**Addendum No. 2**  
**July 29, 2024**

Project: Brandon Valley Elementary School  
Brandon, South Dakota  
Project #3023

Architect: Architecture Incorporated

MEZZANINE PLAN - AREA D

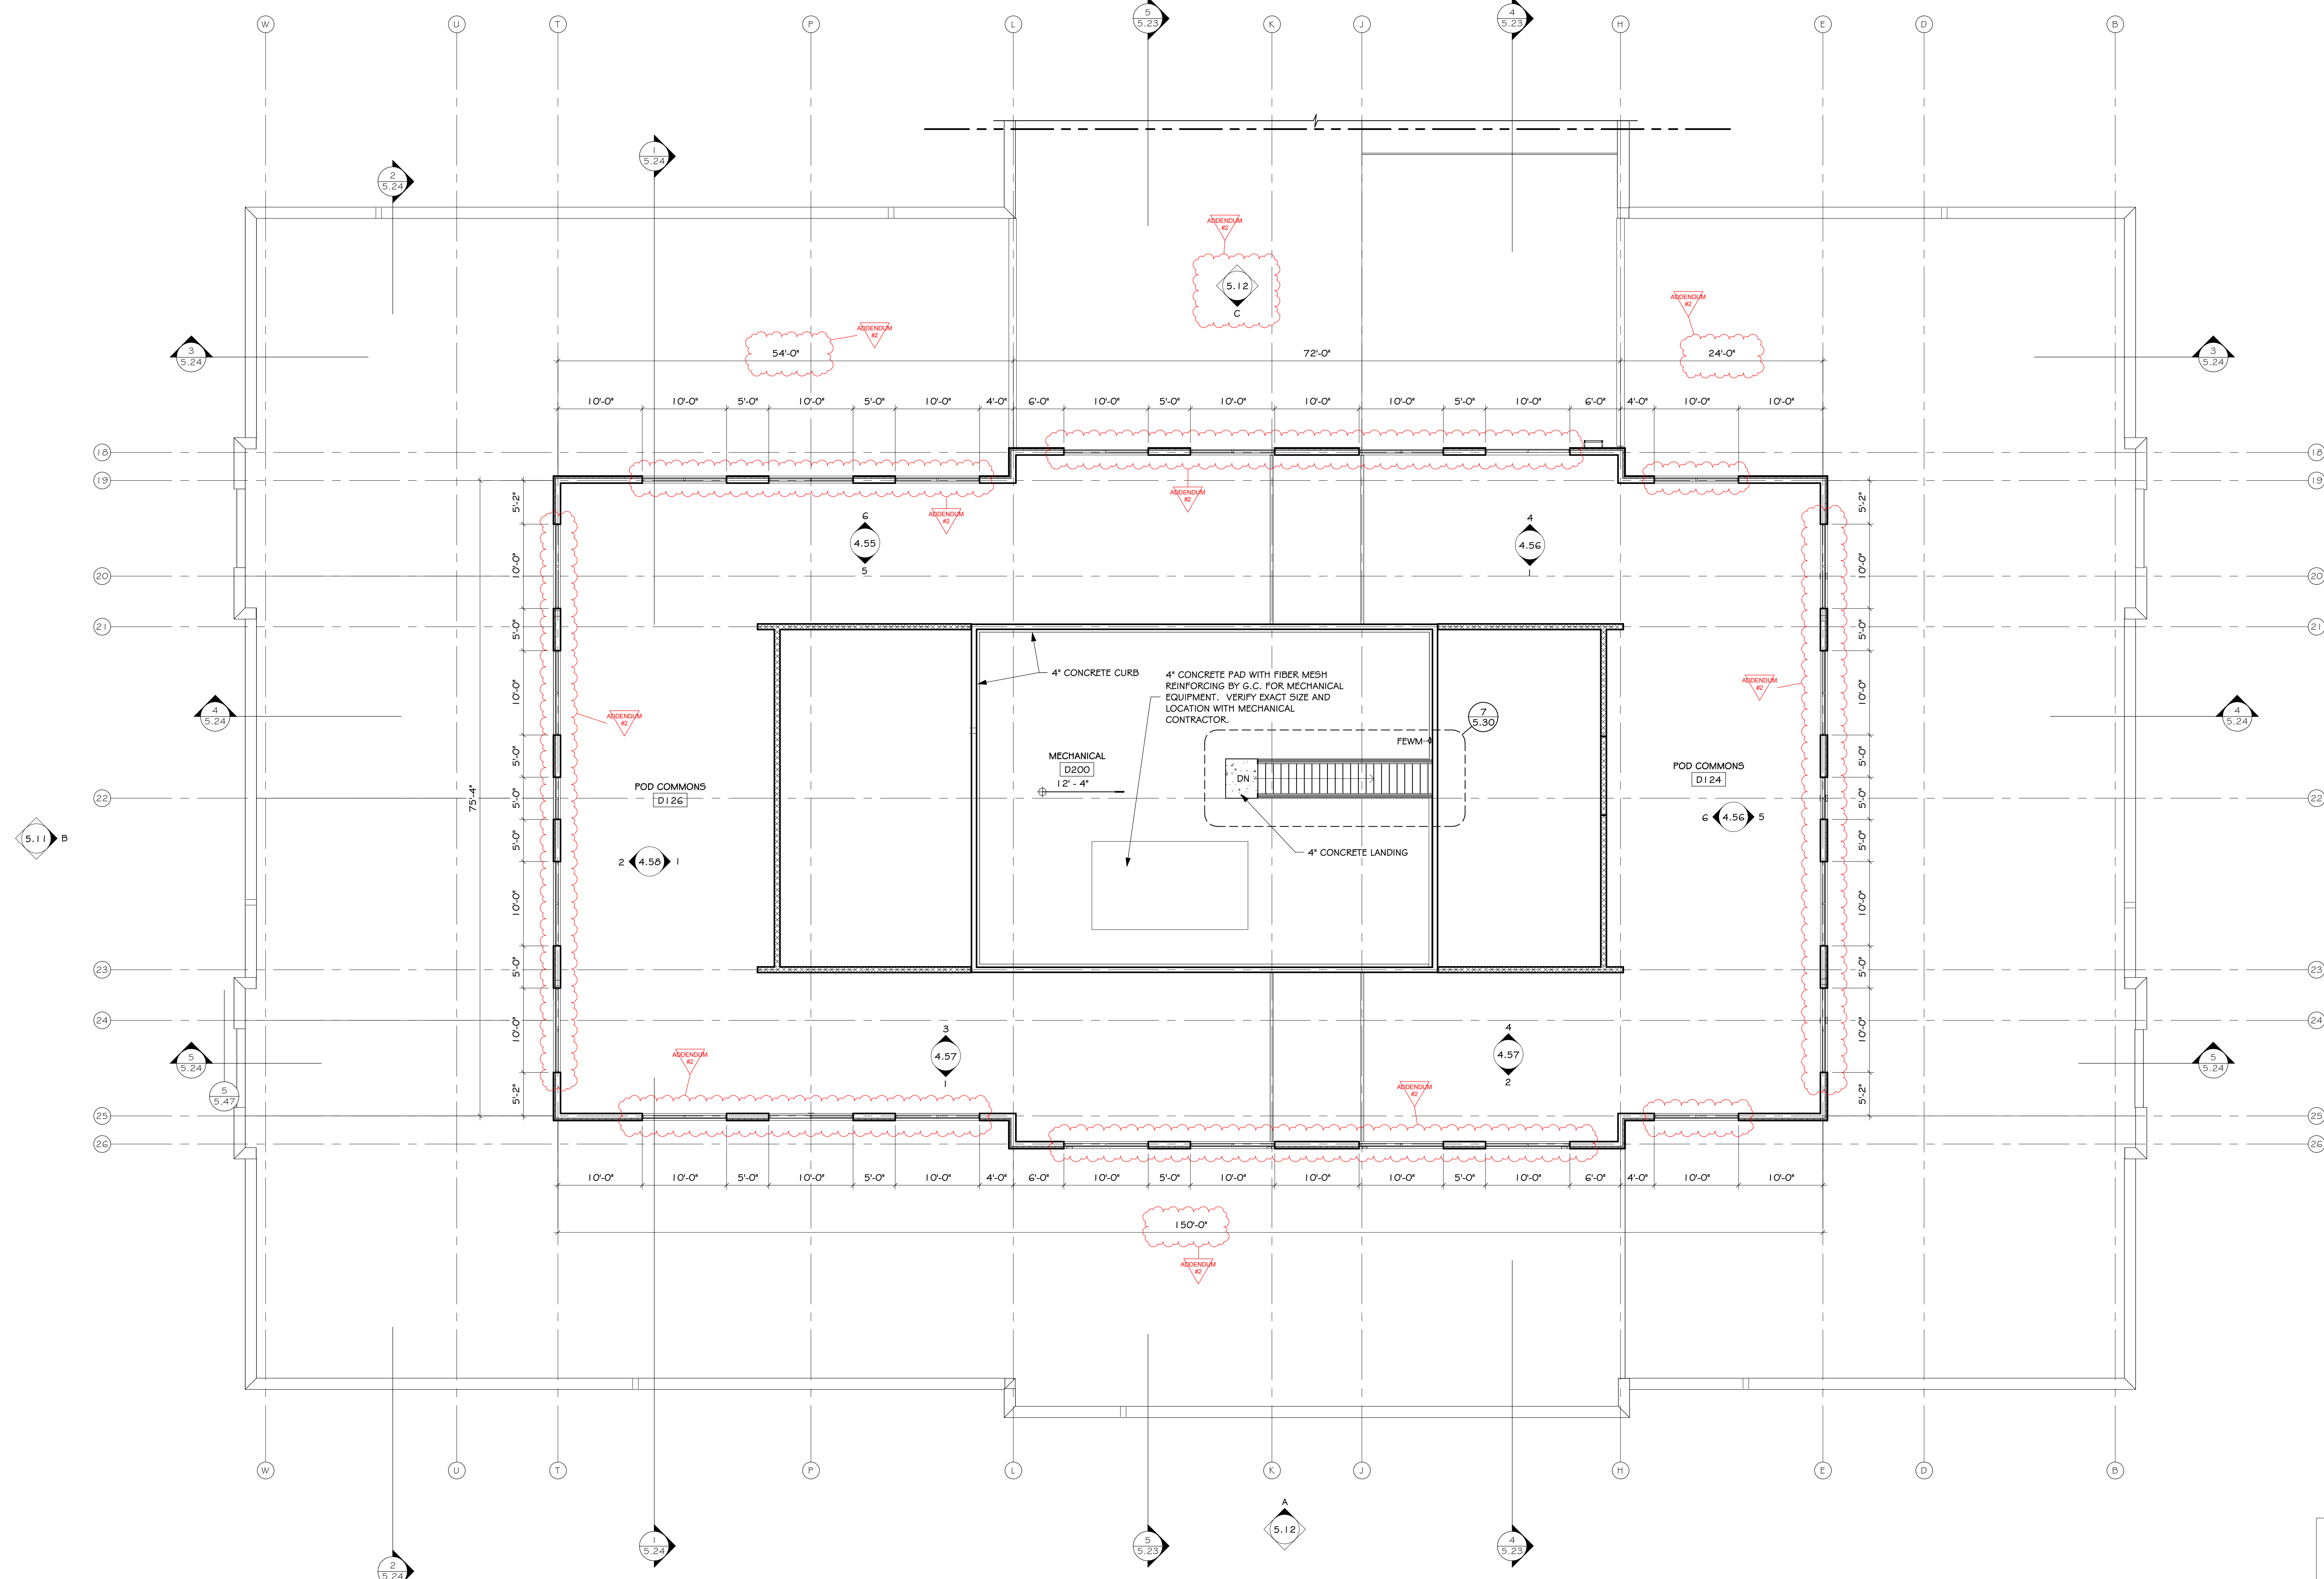
- a) Reference *revised* drawing Sheet 4.11D, *revision* dated 7-26-2024, attached to the end of Addendum #2 for the following modifications:
- i) The floor plan has been adjusted to show clerestory windows originally on the floor plan.
- ii) Overall dimension has been added along the east and west sides of the mezzanine floor plan as indicated.

**FLOOR PLAN - AREA A - LIGHTING**

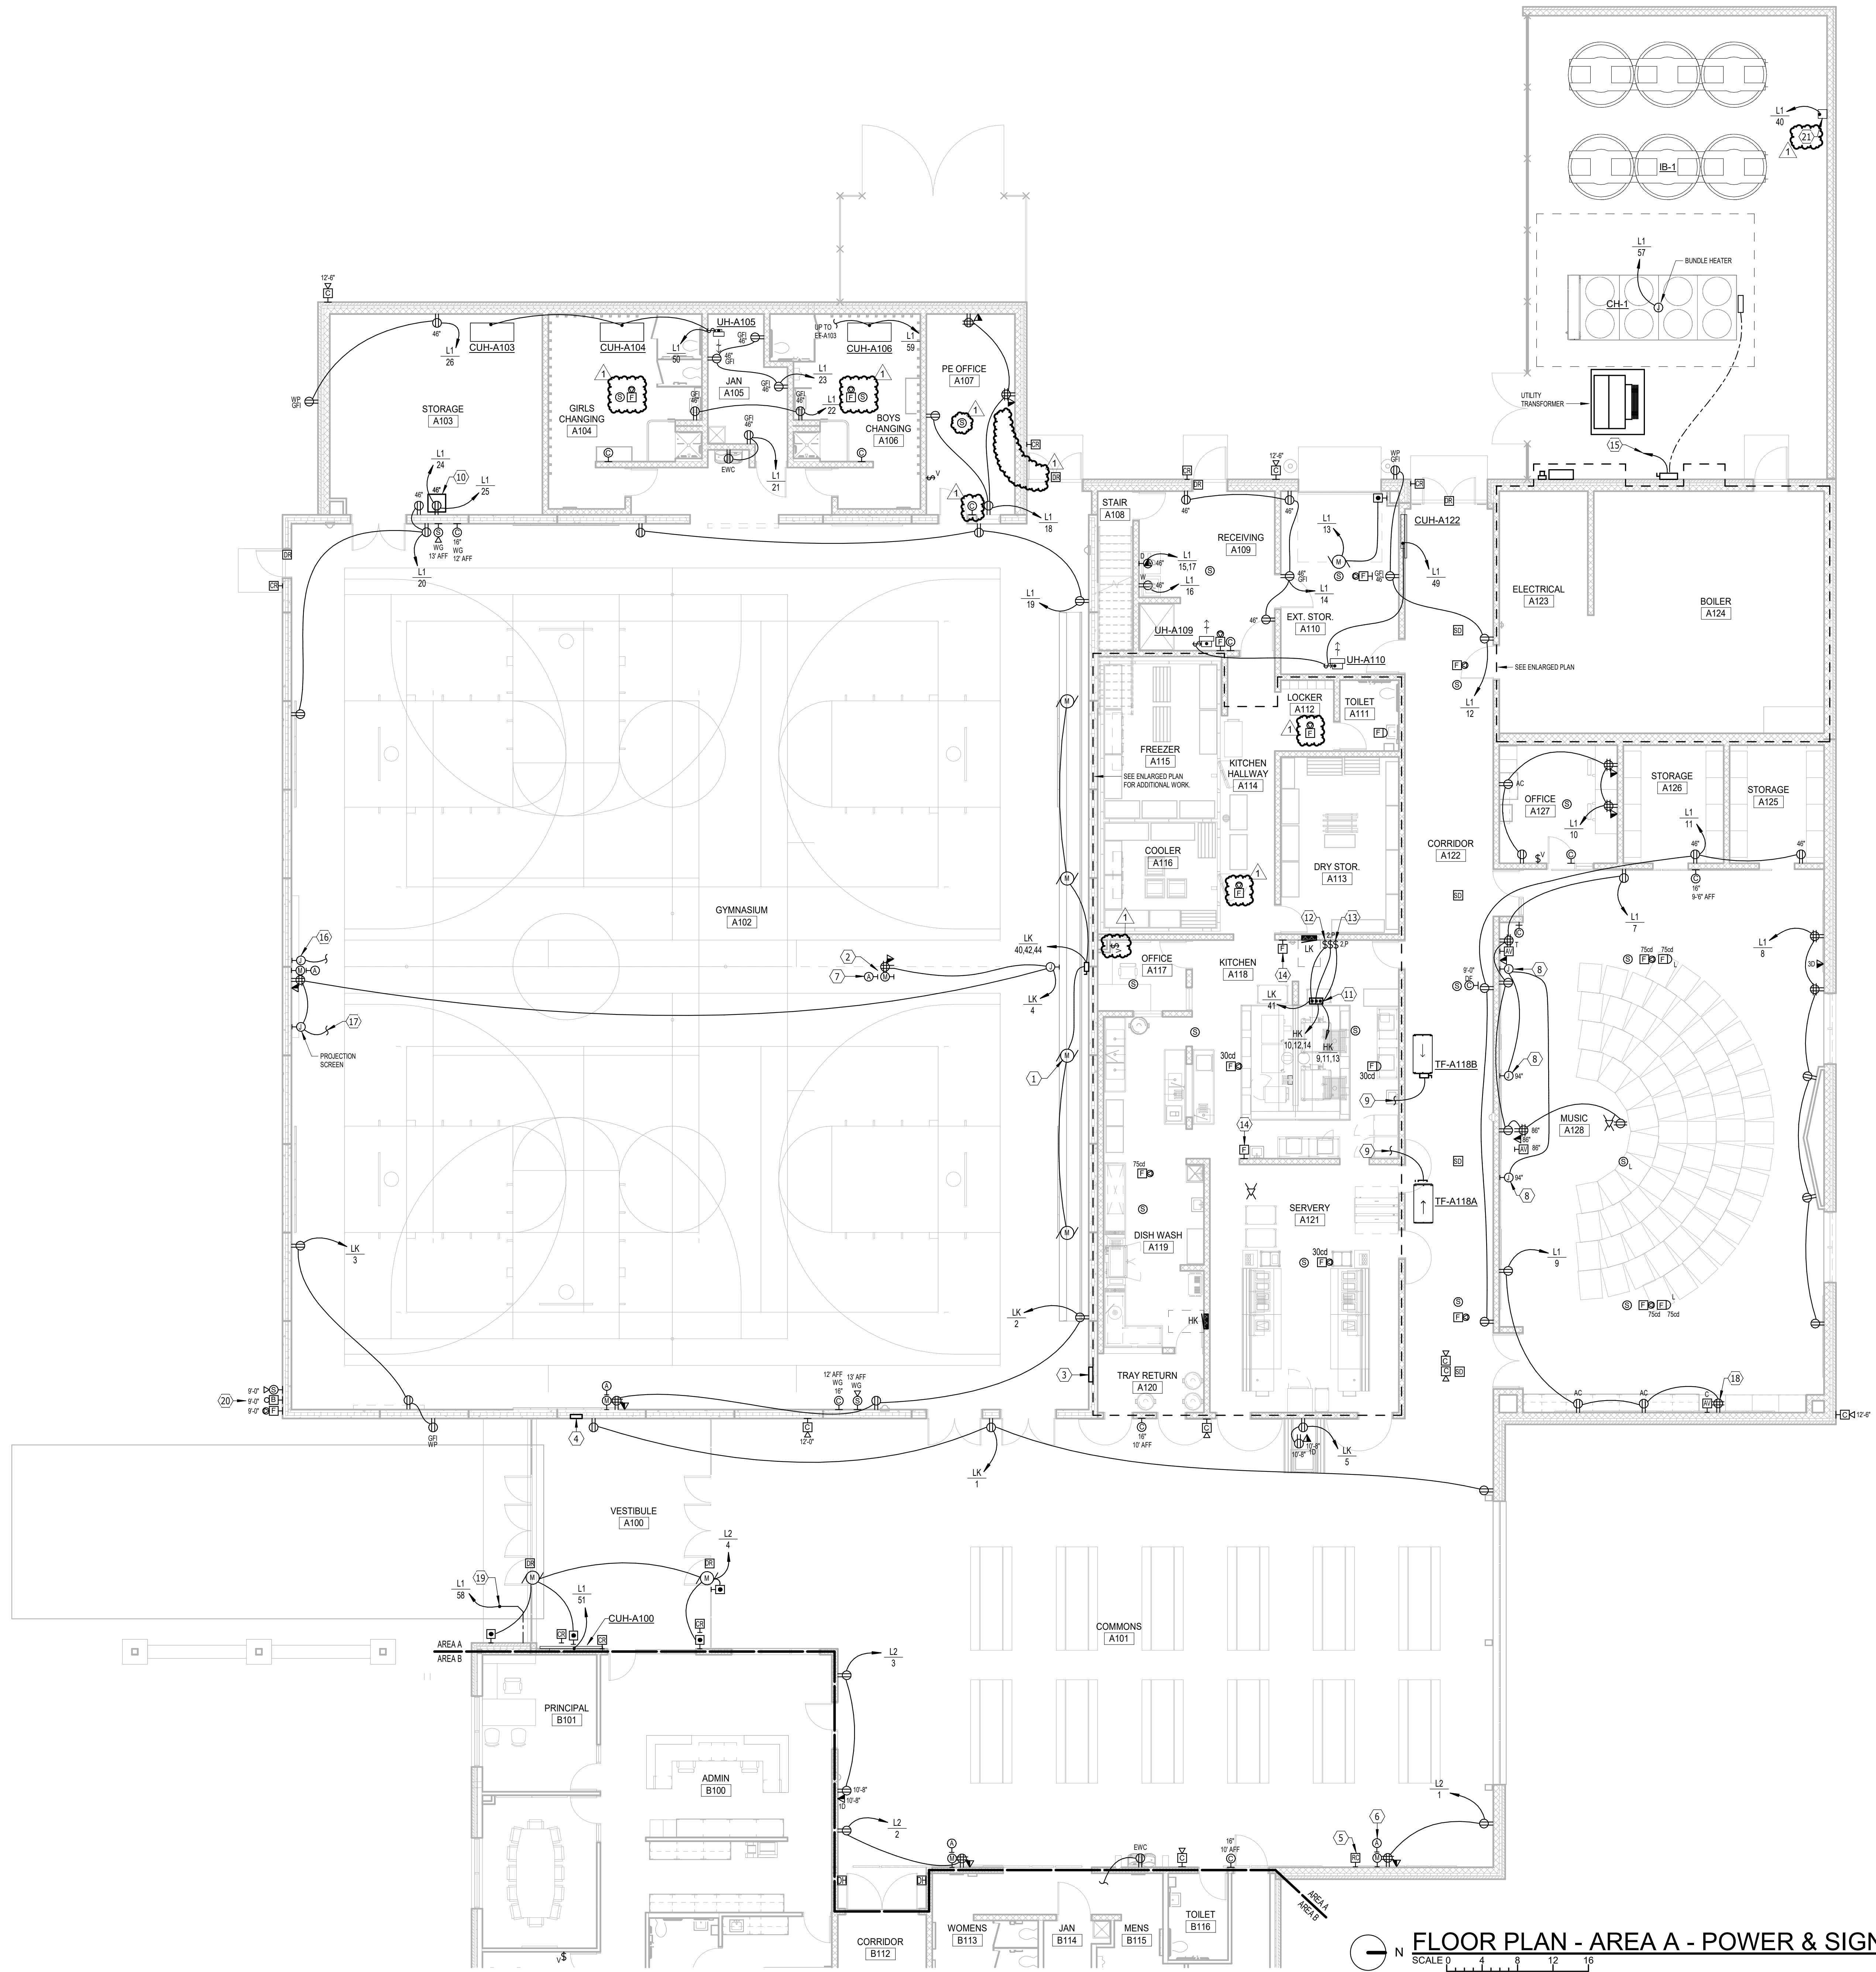
- a) The luminaire types and locations at room A112 has been updated as indicated in the *revised* drawing Sheet 9.21, *revision* dated 7-26-2024, attached to the end of Addendum #2.

**SECOND FLOOR - AREA A - POWER & SIGNAL**

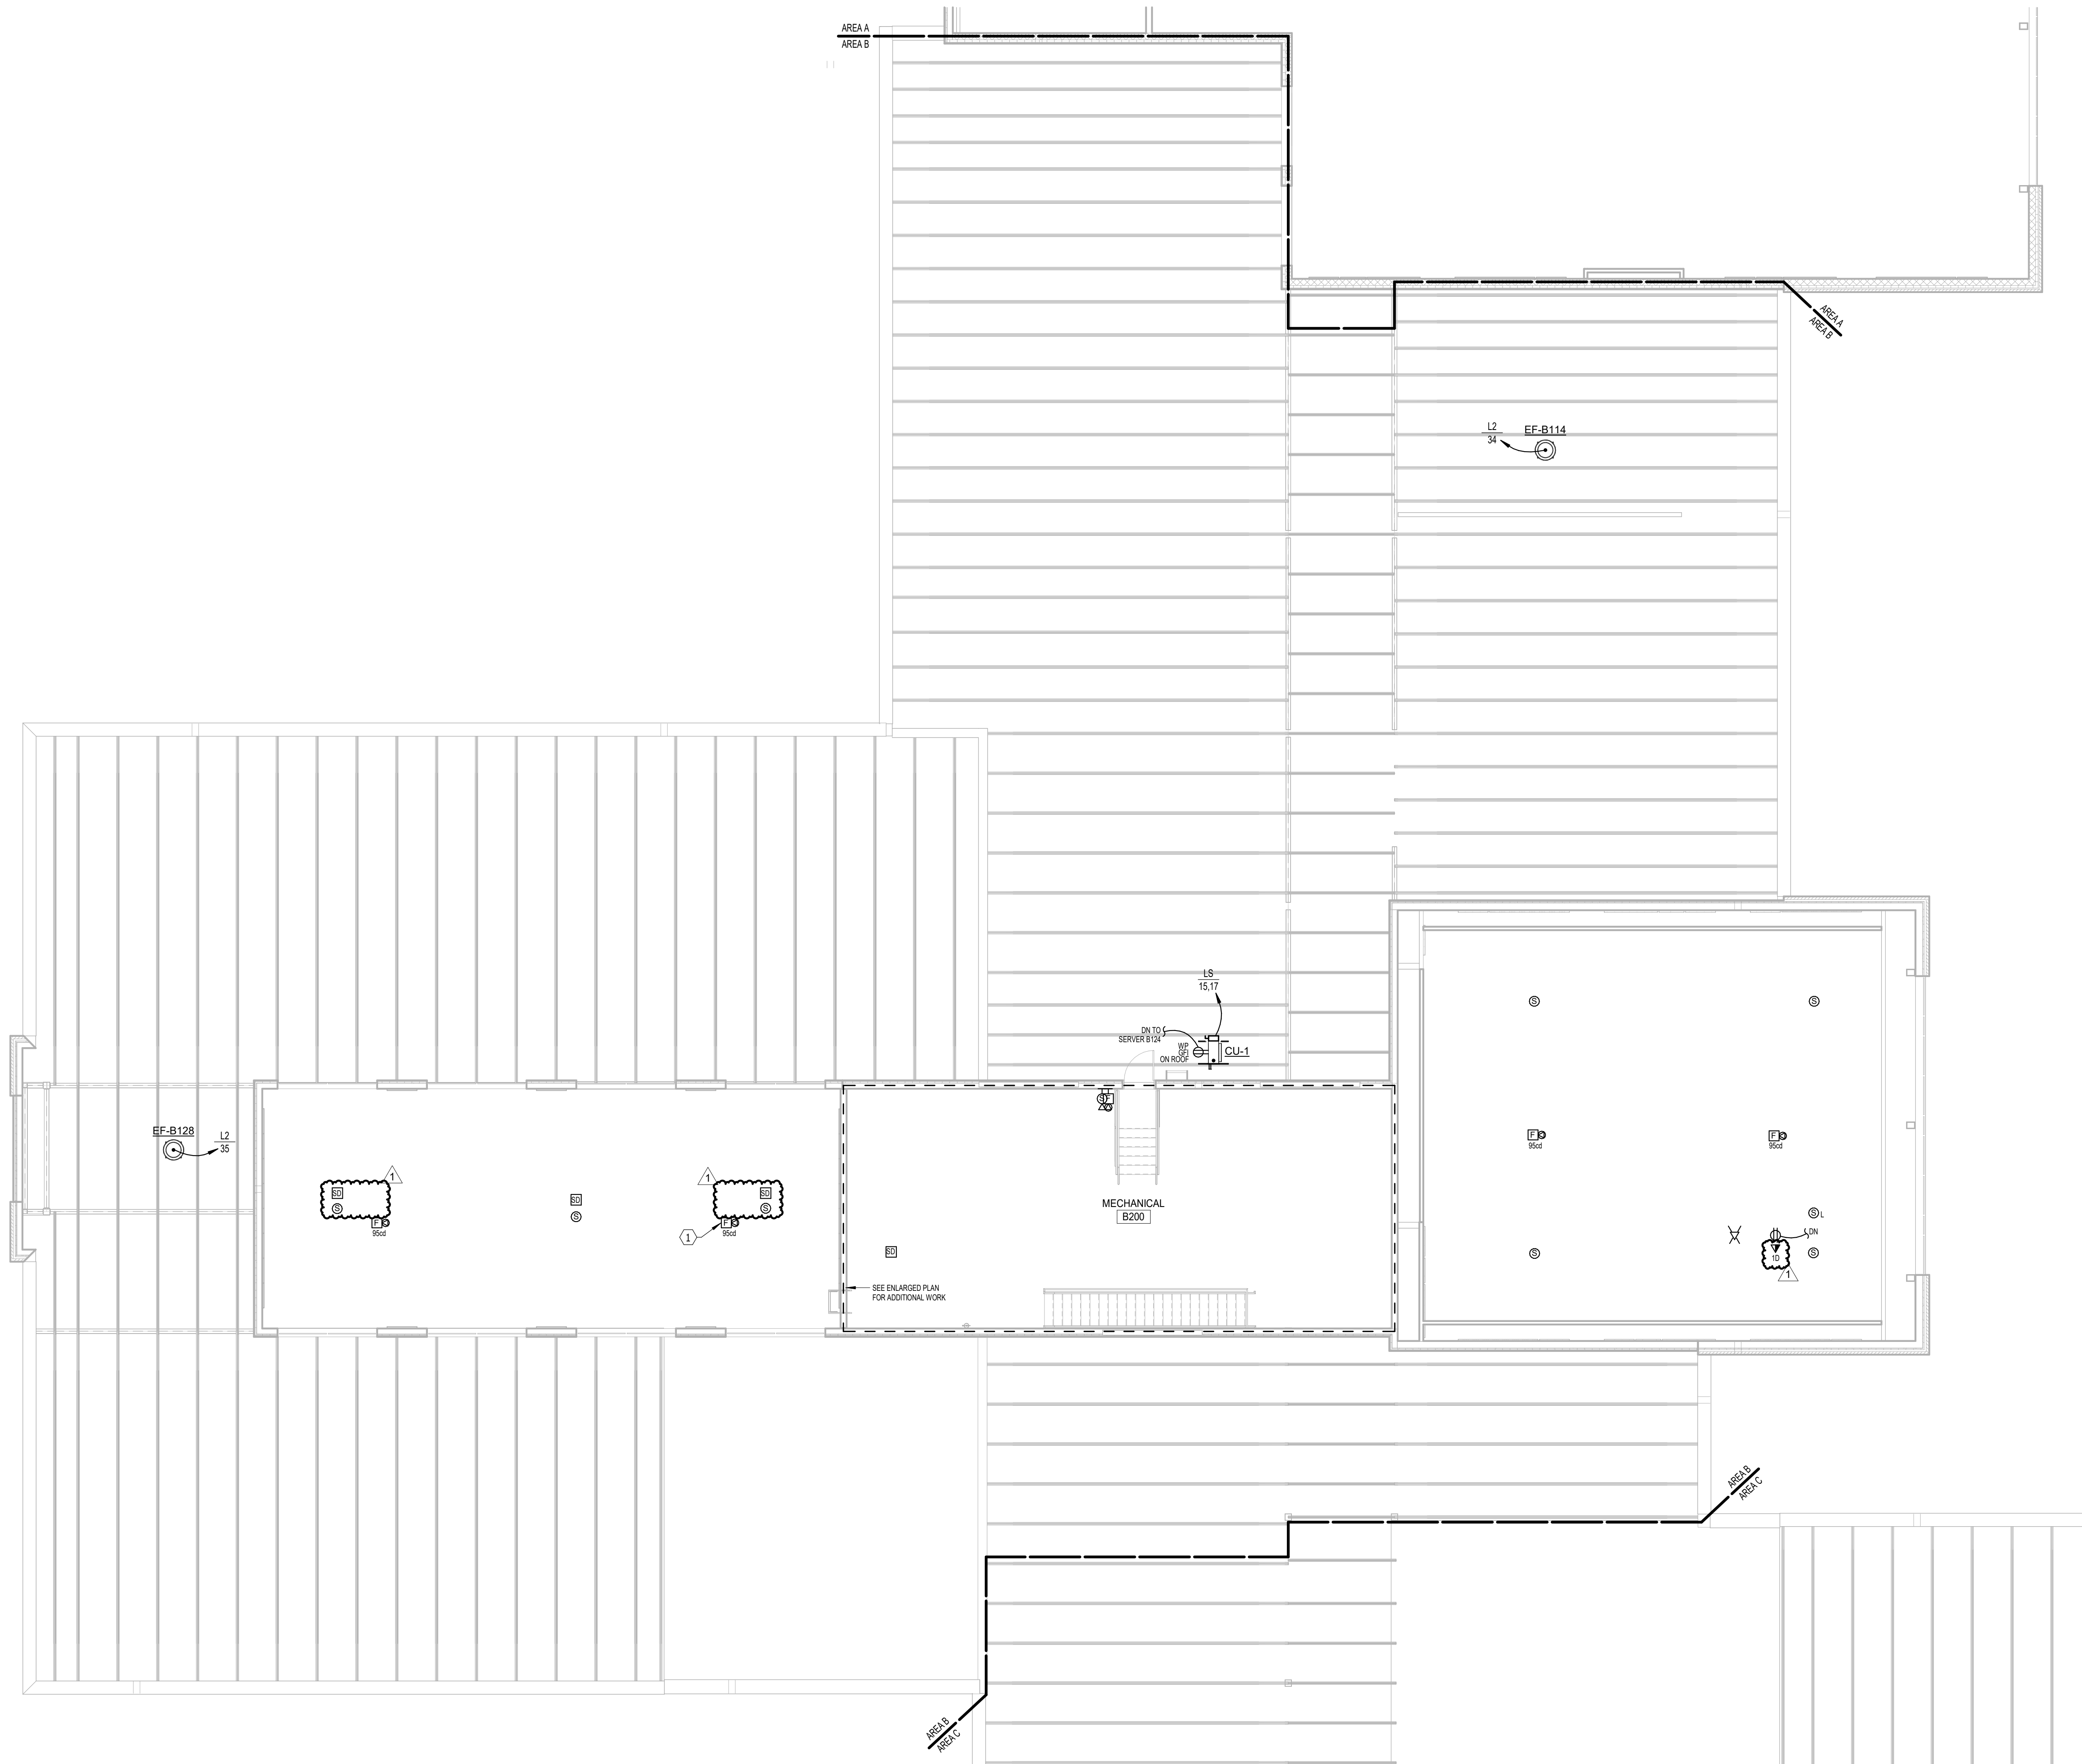
- a) The location of WAP in room A101 has been updated as indicated in the *revised* drawing Sheet 9.32, *revision* dated 7-26-2024, attached to the end of Addendum #2.
